Deadline 3
15 December 2020.

PINS reference. EA1N: IP: 20224031. AFP: 132.
EA2: IP: 20224032. AFP: 0134.

Responses to submission and Comments received at Deadline 2. These remarks apply to both EA1N and EA2.

11.3. Abstractions.

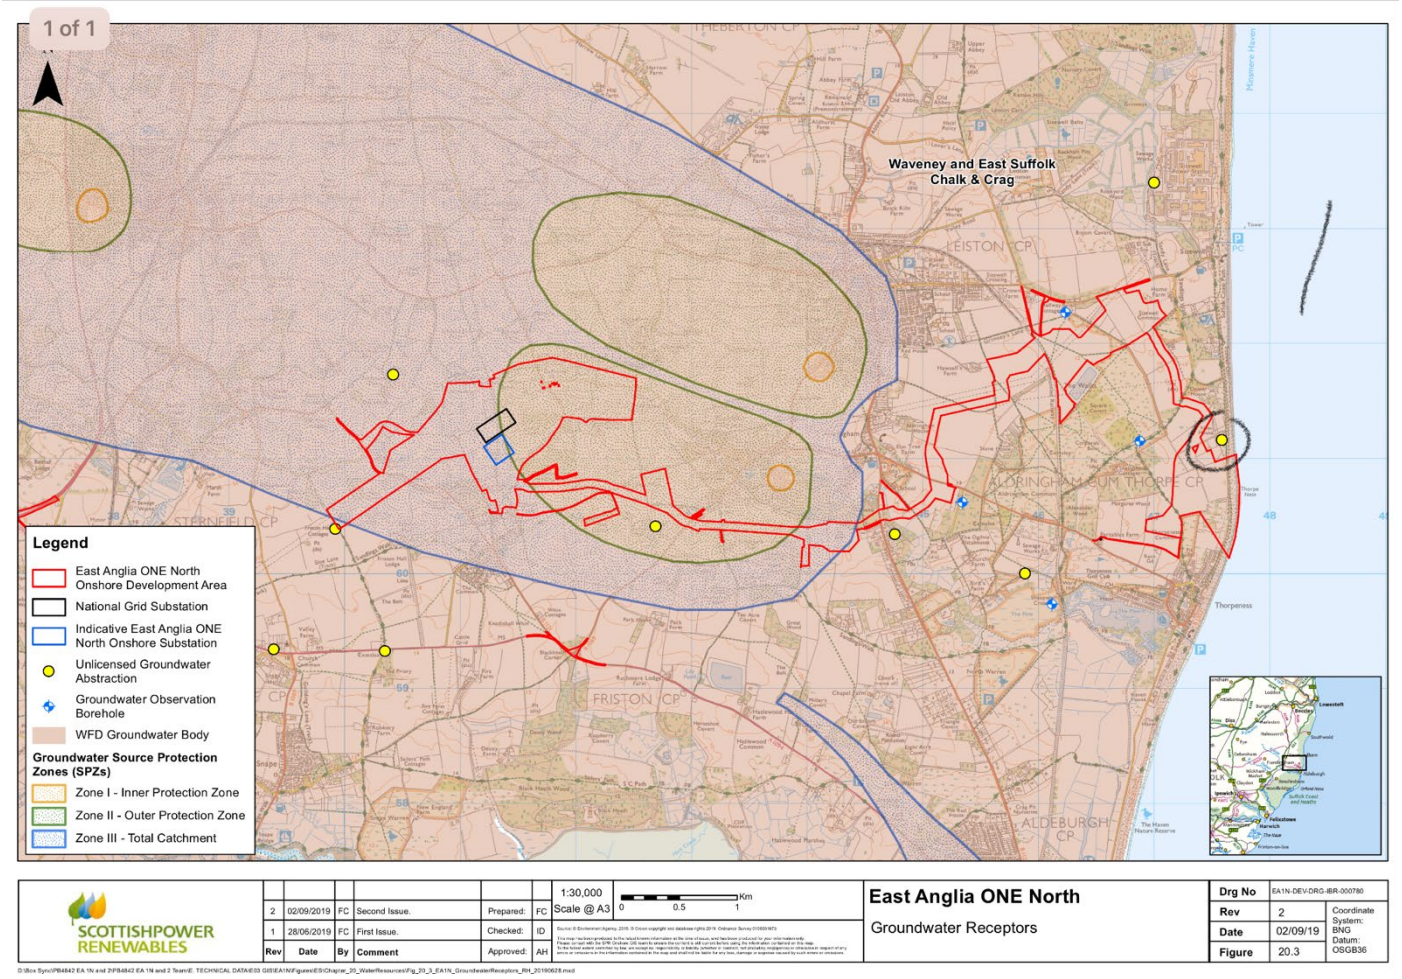
Why weren't we told?

In response to my own representations on this subject, the Applicants have no response at all.

Although this registered and licensed aquifer has been clearly represented to the Applicant as providing the sole water supply for three households, and a centre providing residential care for vulnerable young and old, with full details of licensing registration , – and indeed the Applicant's response opens using that same term, aquifer- they reply in terms of the minimum working distance required of them in respect of a borehole of 250m, and not even the more generous 500 m allowed for groundwater dependent ecological sites. Boreholes are not the issue here. Neither are ecological sites. It is a question of human health and private rights. This response is shockingly beside the point.

These minimal and inappropriate undertakings (in respect of our water supply) to which the Applicant refers do not in fact appear in the CoCP. The updating required by the Environmental Authority appears not to have taken place.
